Form C-103
May 27, 2004

7. Lease Name or Unit Agreement Name
NMNM88525X
BURCH KEELY UNIT
8. Well Number 69

OTHER: MECHANICAL INTEGRITY TEST ☒

From: Guye, Gerry, EMNRD
Sent: Friday, April 07, 2006 7:51 AM
To: production@marbob.com
Subject: Burch Keely Unit #69

BK4 69

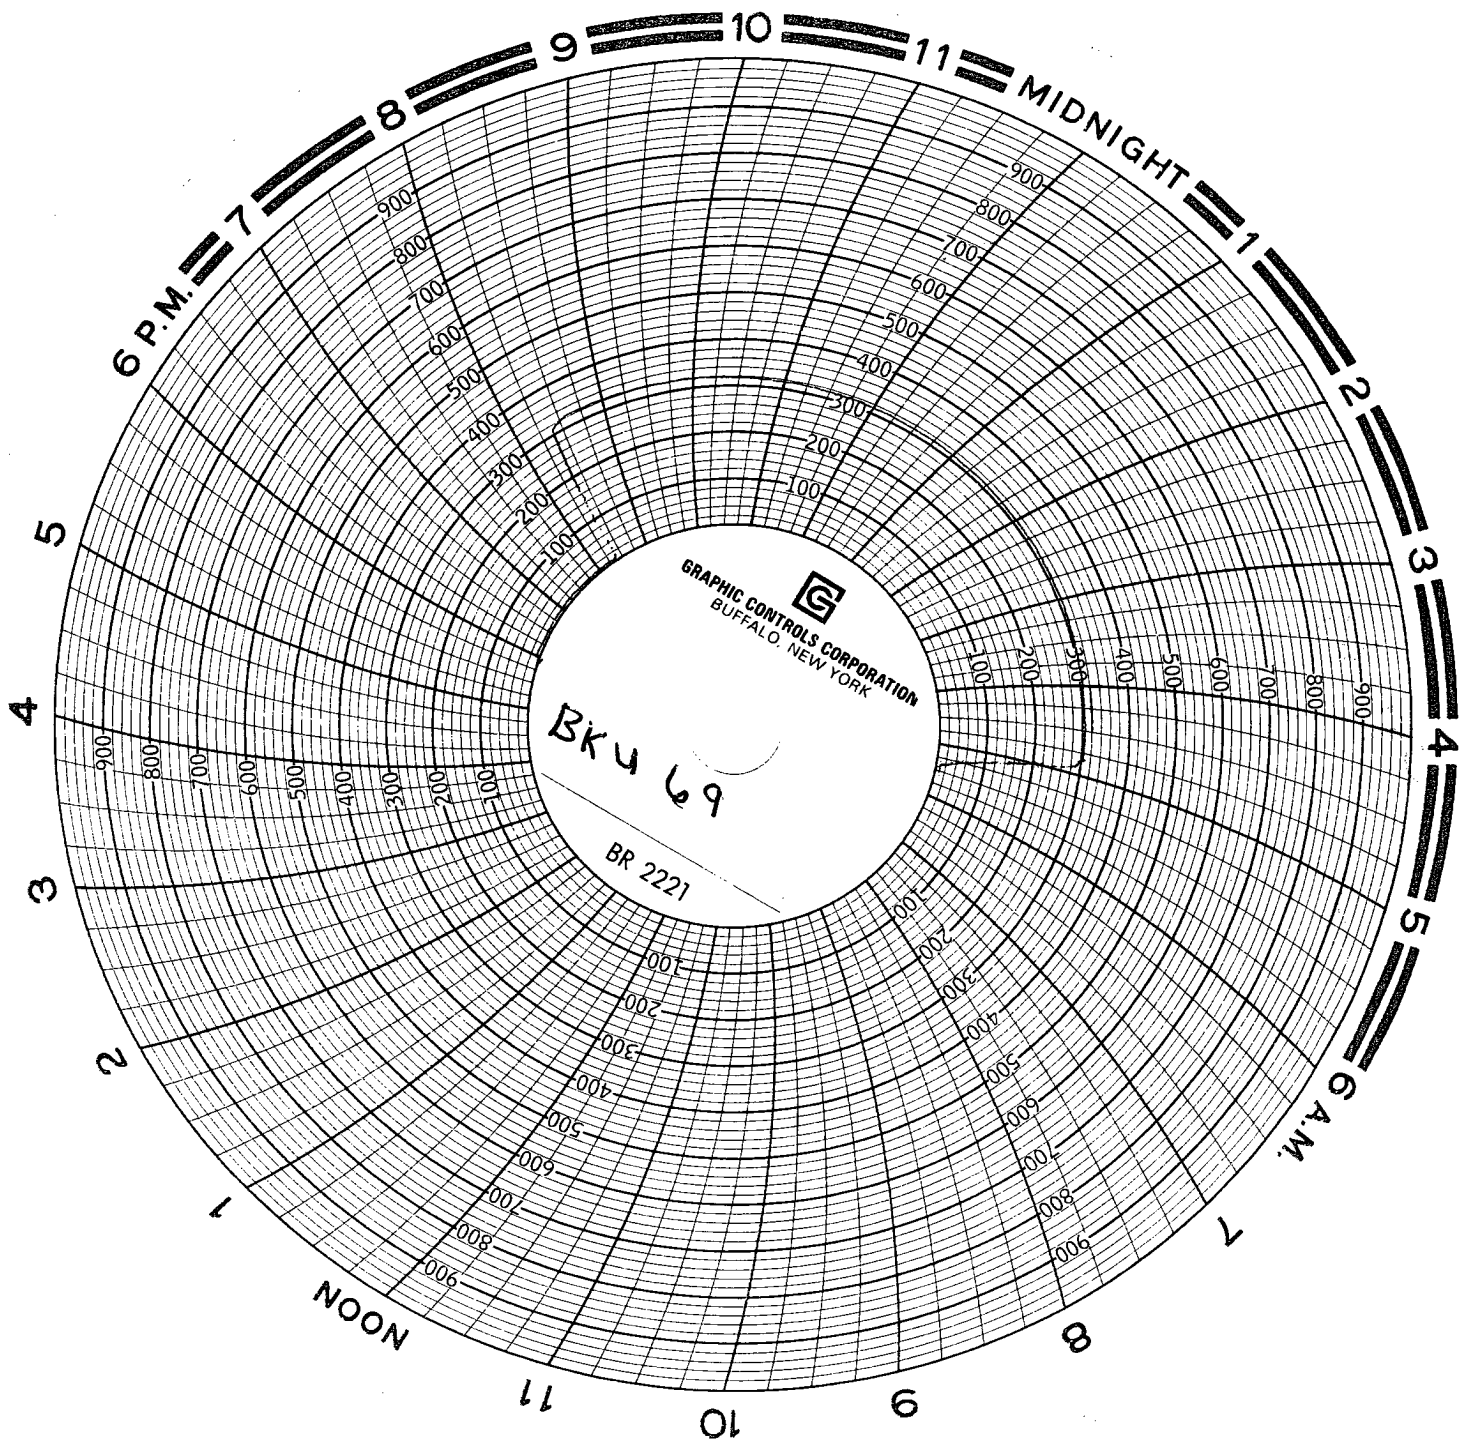
3/31/06 - PRESSURE TESTED TUBING/CASING ANNULUS TO 320# FOR 30 MINUTES.
LOST 20# IN 30 MINUTES. PUT WELL BACK TO INJECTING.
(SEE CHART ATTACHED)

Authority to inject
Denied - Reference NMOC
Rule 19.15.12.1103

I am in receipt of a C-103 for the above well with a chart attached. Everything is in order except you did not indicate on the form what action was taken to prepare the well for this test. Since this was to repair a failed MIT test, I need to know what was done to the well. Please re-submit the C-103 with this information and I will attach the original chart to it.
